Multiword DMA Timing Diagram Proposal

D99132R0

Pete McLean
Maxtor Corporation
31 September 1999

Figure aa – Initiating a Multiword DMA data transfer

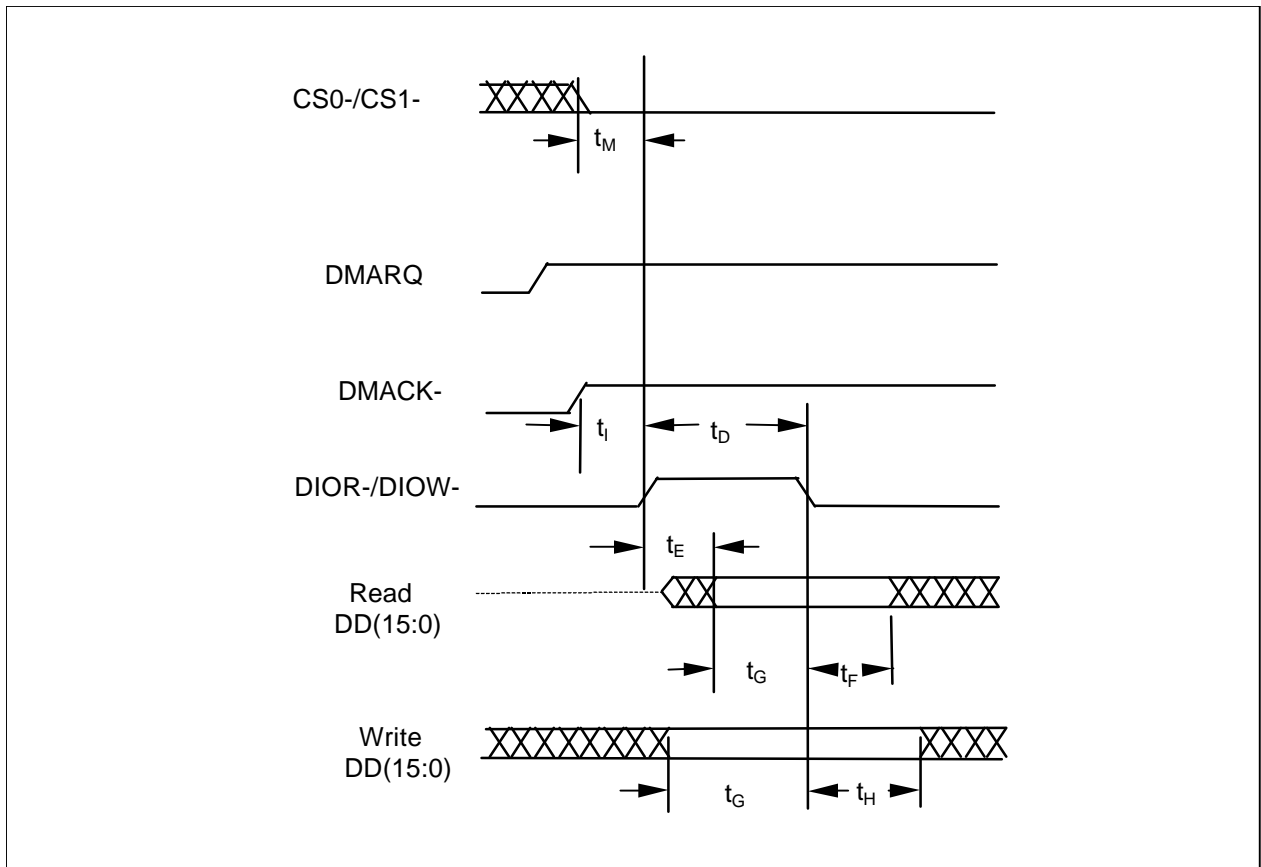
It is proposed that clause 10.2.3 be replaced with the following:

10.2.3.1 Initiating a Multiword DMA burst

The values for the timings for each of the Multiword DMA modes are contained in 10.2.3.

Figure bb – Sustained Multiword DMA data transfer

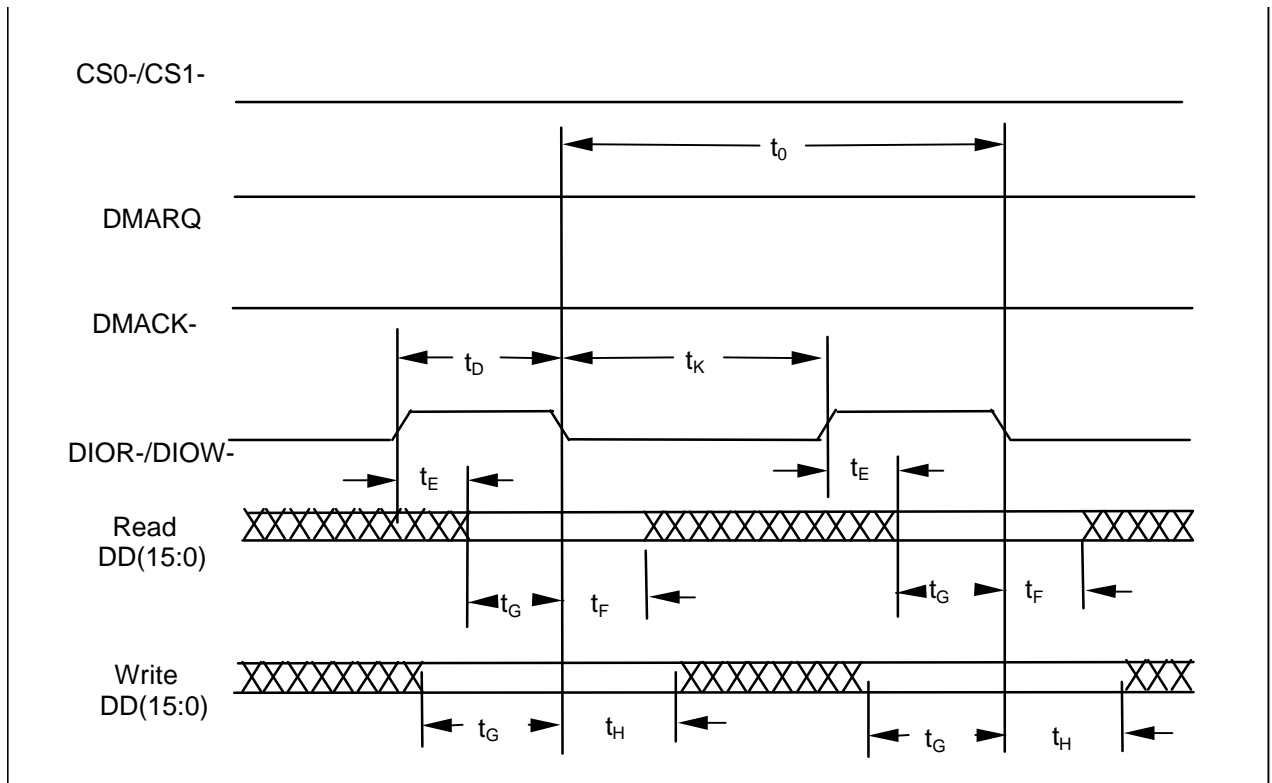
10.2.3.2 Sustained Multiword DMA burst

The values for the timings for each of the Multiword DMA modes are contained in 10.2.3.

Figure cc – Device terminating a Multiword DMA data transfer

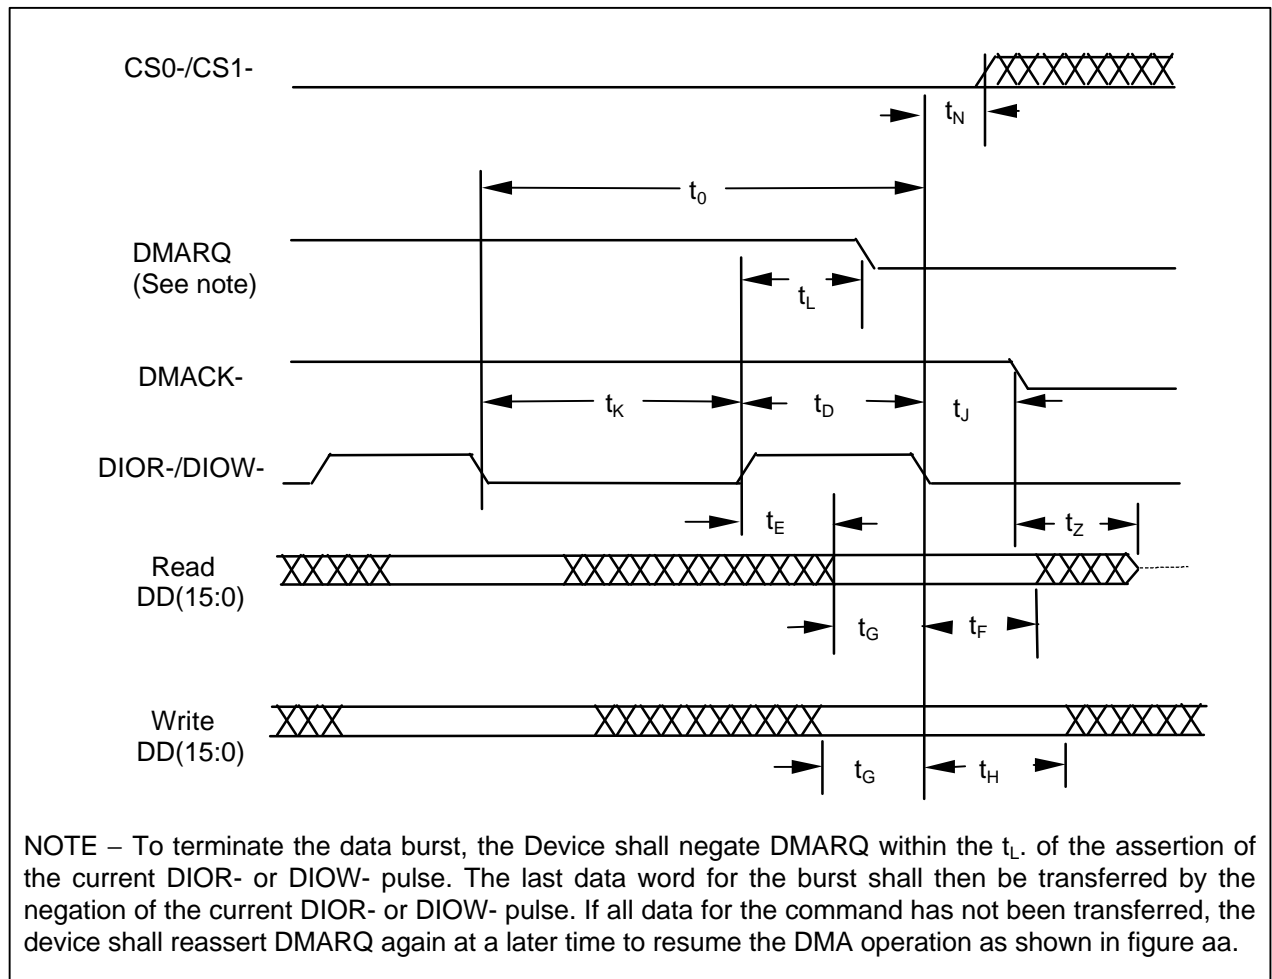
10.2.3.3 Device terminating a Multiword DMA burst

The values for the timings for each of the Multiword DMA modes are contained in 10.2.3.

Figure dd – Host terminating a Multiword DMA data transfer

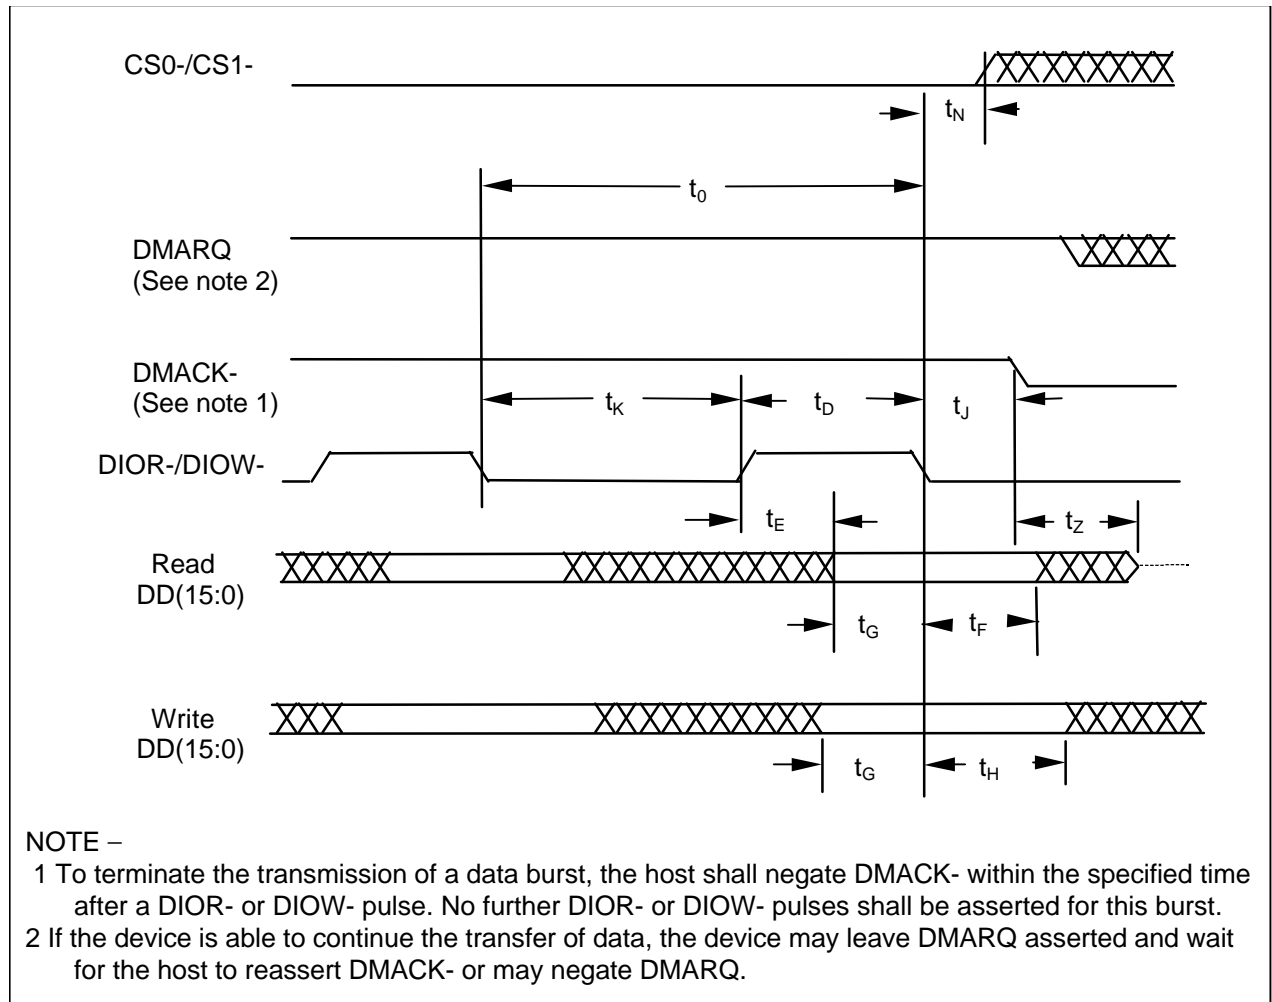
10.2.3.4 Host terminating a Multiword DMA burst

The values for the timings for each of the Multiword DMA modes are contained in 10.2.3.
